SEWAGE DISPOSAL SYSTEM
HOWARD COUNTY HEALTH DEPARTMENT
BUREAU OF ENVIRONMENTAL HEALTH
410-313-2640

SUBDIVISION _____ LOT NUMBER _____ ADDRESS 10706 Hunting Lane

RE: **Variance Approval**
10706 Hunting Lane
Columbia, MD 21044

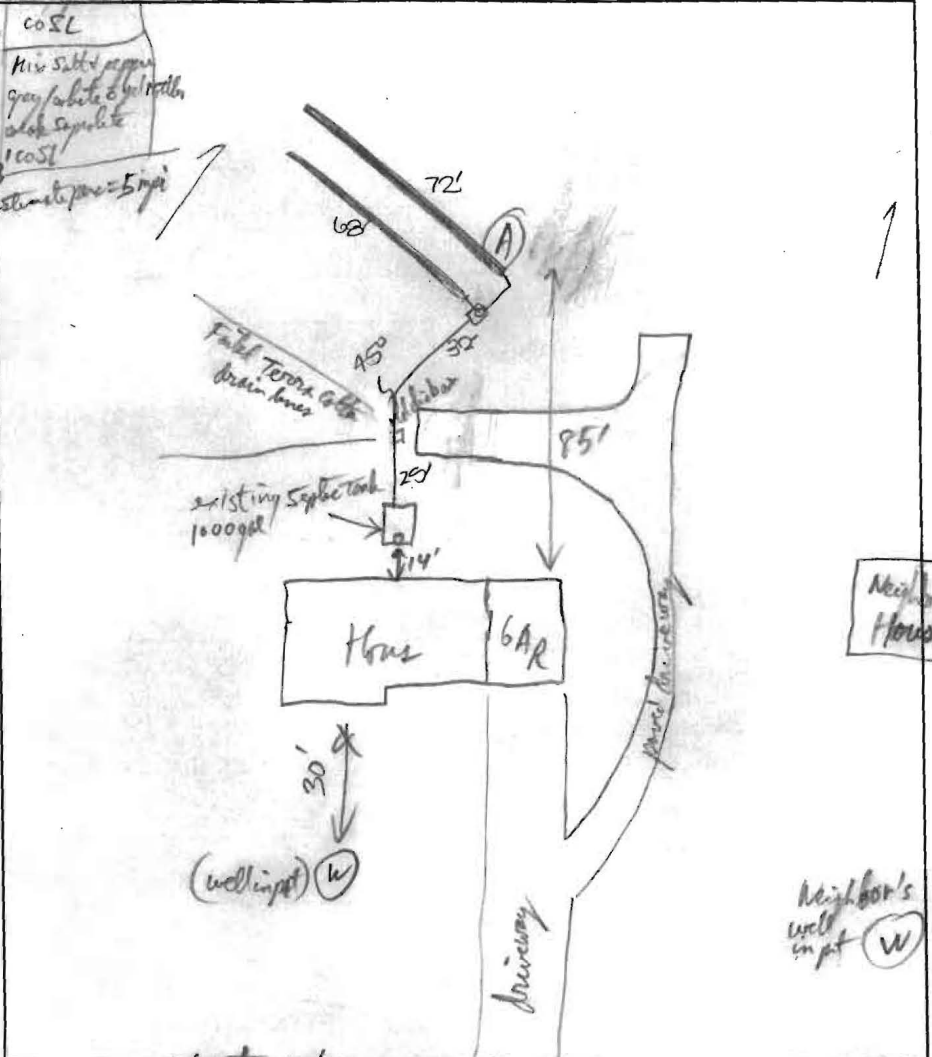
PRE-CONSTRUCTION INSPECTION: System Not Failing - old drainlines (terra gotta) were full of roots (42 yr old) easier to replace New drainfield; Existing 1000gal Septic Tank has new plastic T Baffle & supply piping PPS/9601

INSPECTION COMMENTS: 3/20/01 A.M. OK to gravel trenches and continue work. DIC

3/20/01 P.M. FINAL INSP - OK to cover all septic work. DIC

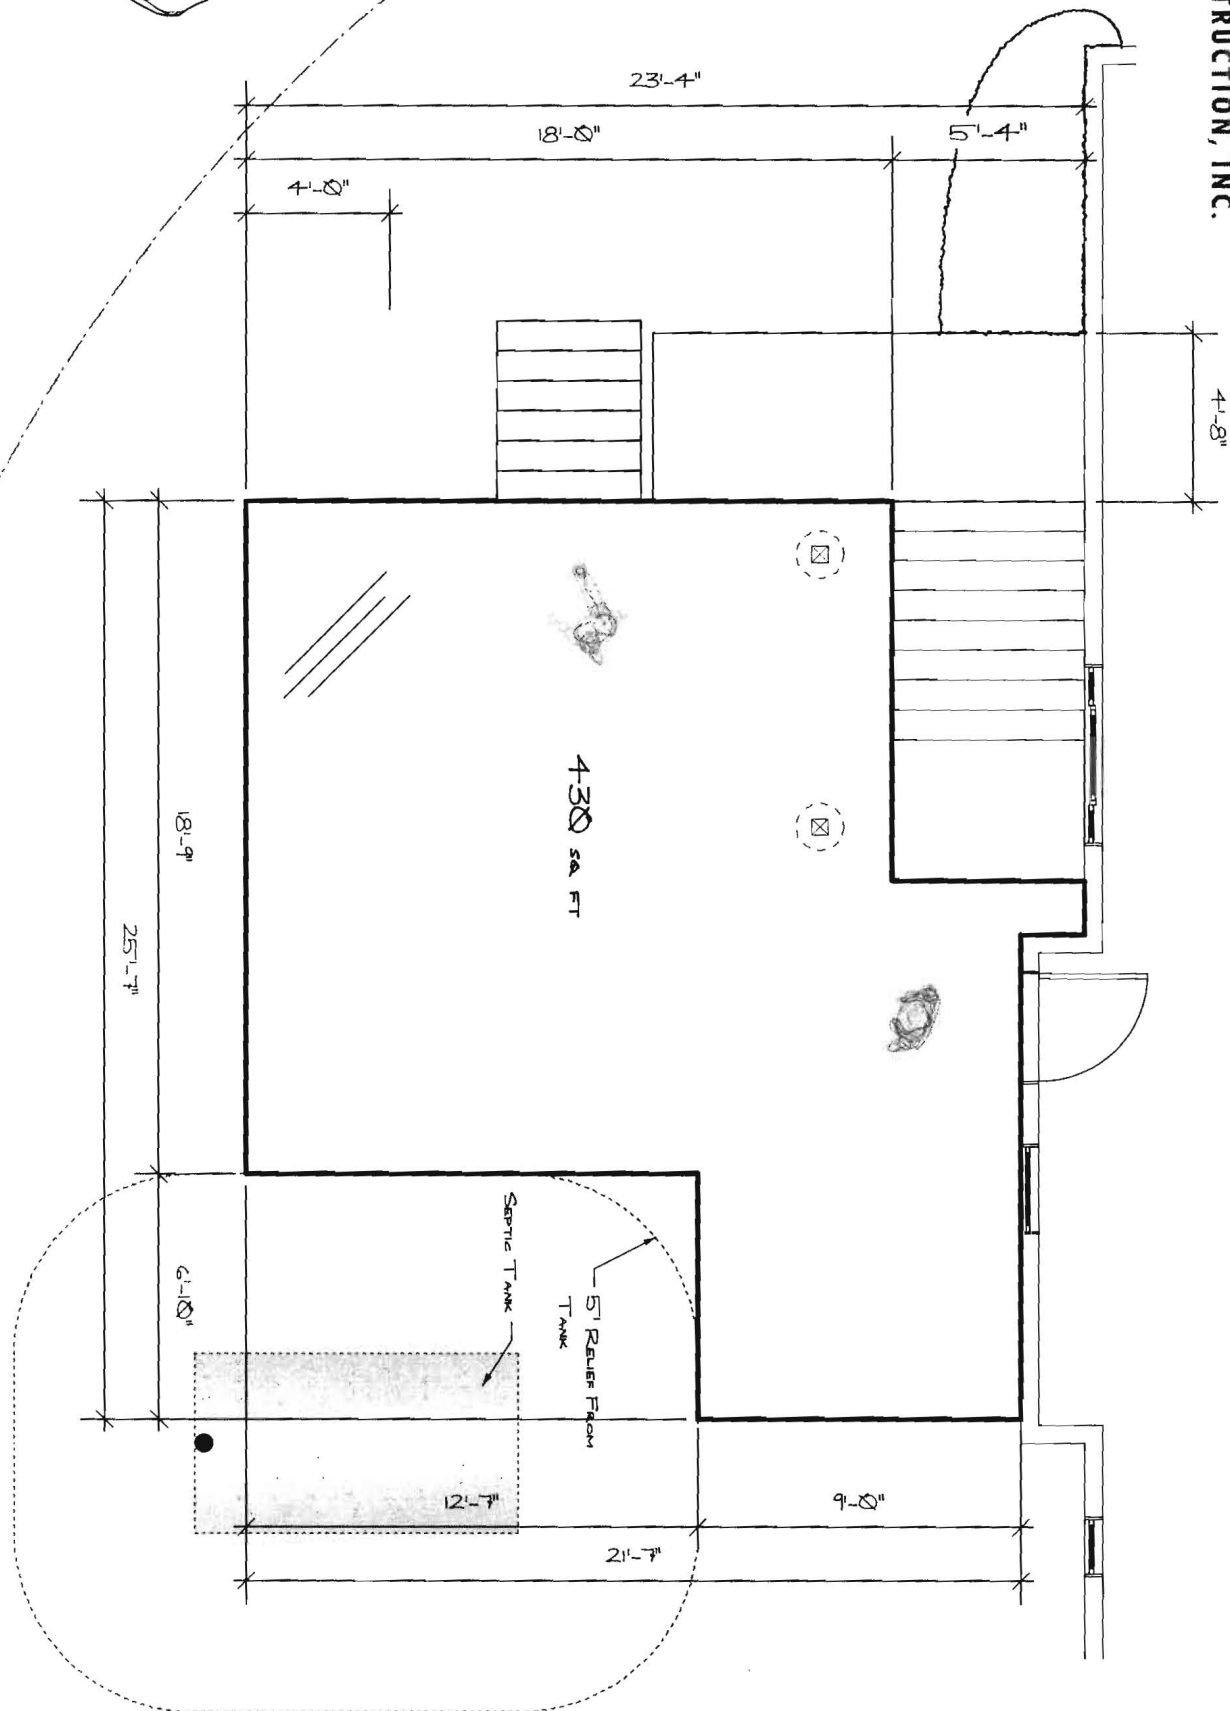
As can be seen in the included plan, I would like to build as close as 5' away from the tank, though no closer. The deck is a post and beam structure, and will sit approximately 48" off of the ground. All other construction related items conform to normal Howard County construction codes and guidelines.

The Department of Health has received your variance request received November 9, 2006 for the above referenced property. This agency will grant **approval** of the variance provided that the deck is constructed with the footers of the deck no closer than five (5) feet to the existing septic tank. Approval of a building permit will be granted by this Department provided that the site plan submitted with the building permit application is consistent with the site plan approved under this variance request and the construction plans illustrate the construction of the footers in compliance with the five (5) foot setback. Any deviations from the site plan submitted with the request will be subject to further review by this Department.

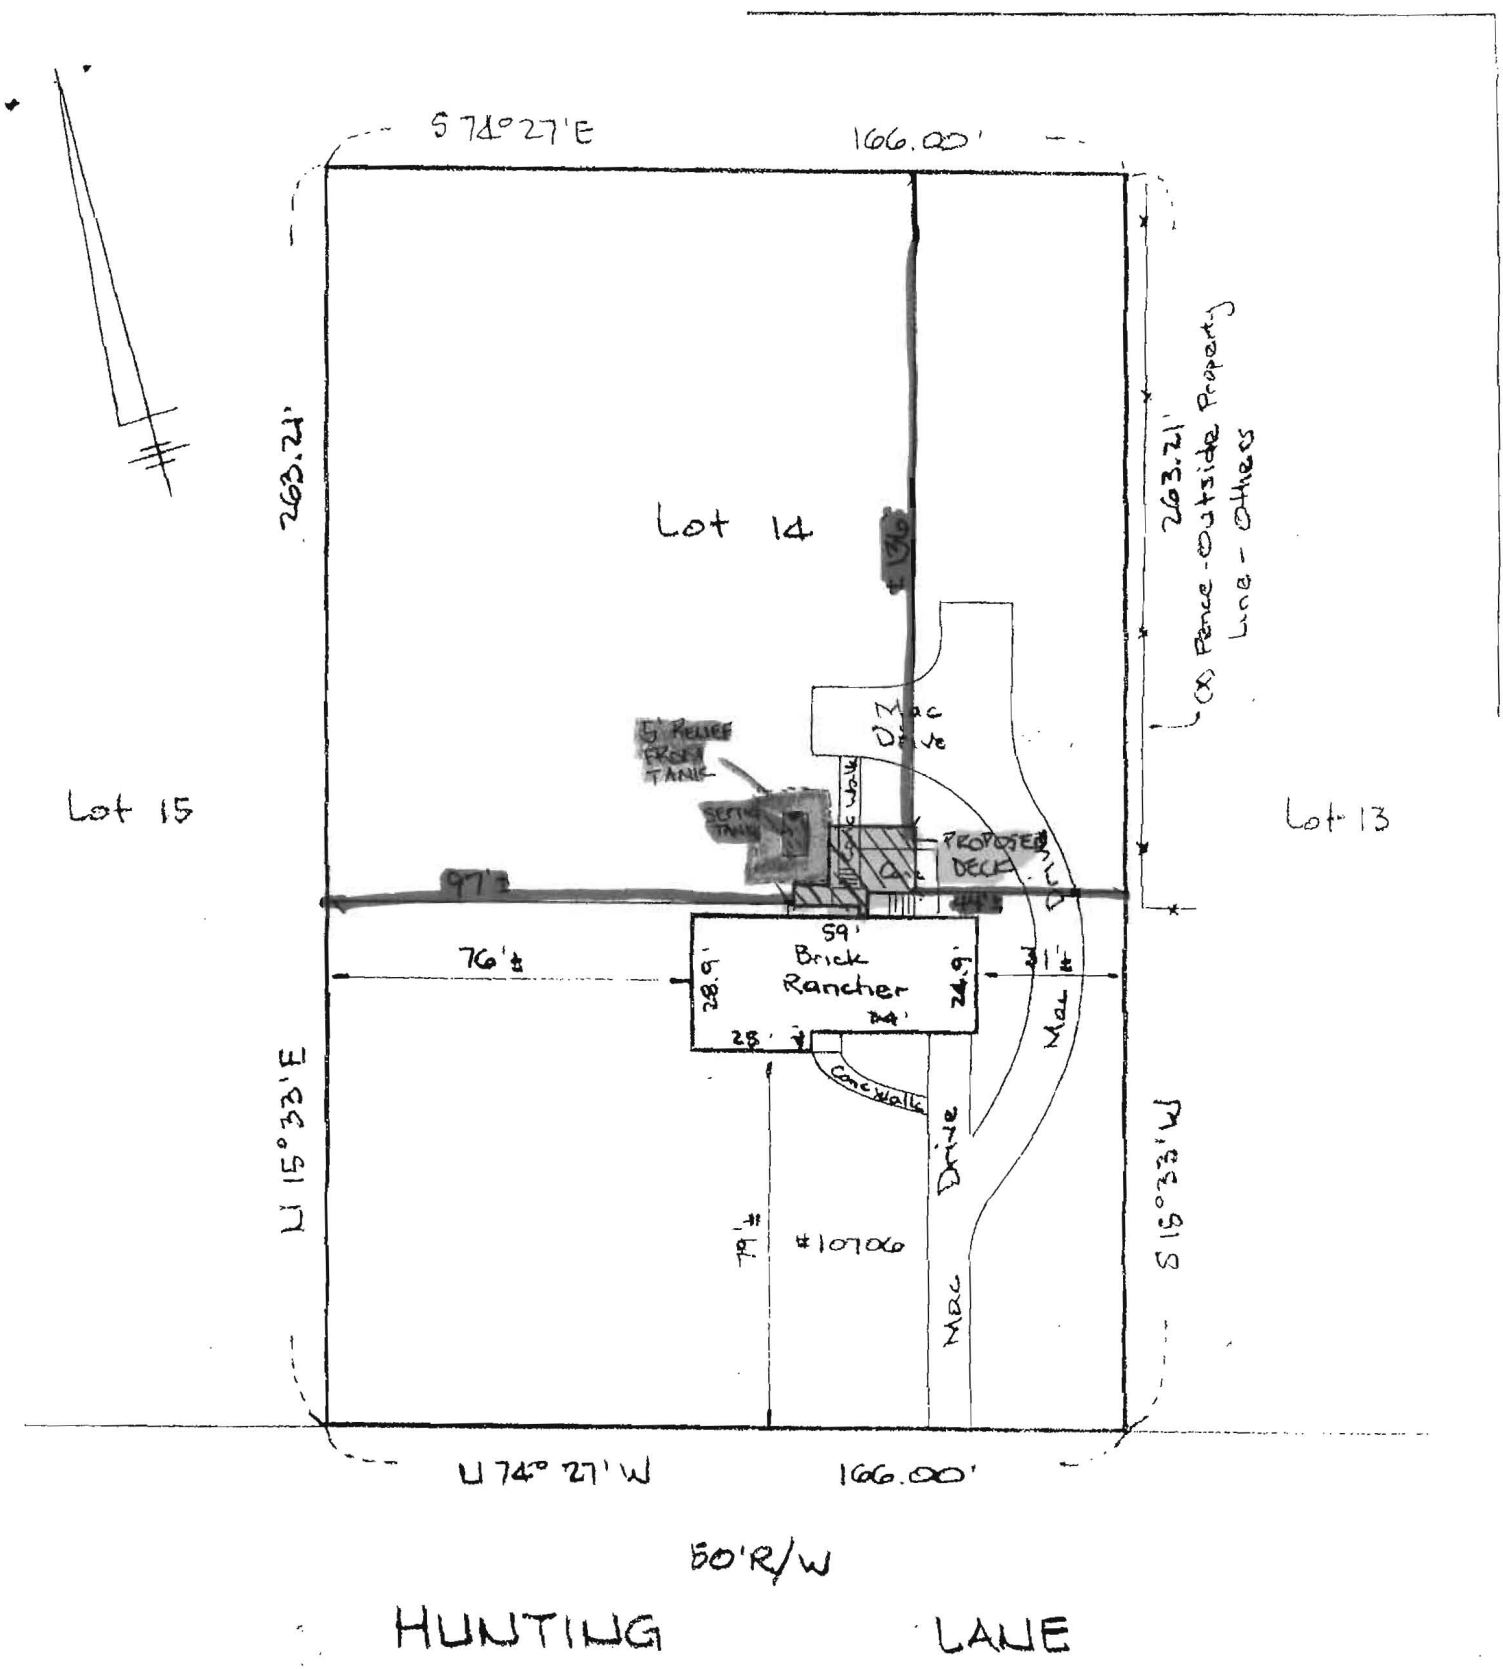
Pro-Built Construction, Inc. has proposed to build a deck on my home that is 25' - 7" x 21'-7" approximately 430 square feet and 48" off the ground. Attached you will find a site plan with the proposed deck drawn. You will see that with this size deck the septic tank will be 5 feet from the structure. We understand that the current Howard County set back for the septic tank is 10 feet, however, we would like to build the proposed deck which would make it a set back of 5 feet.
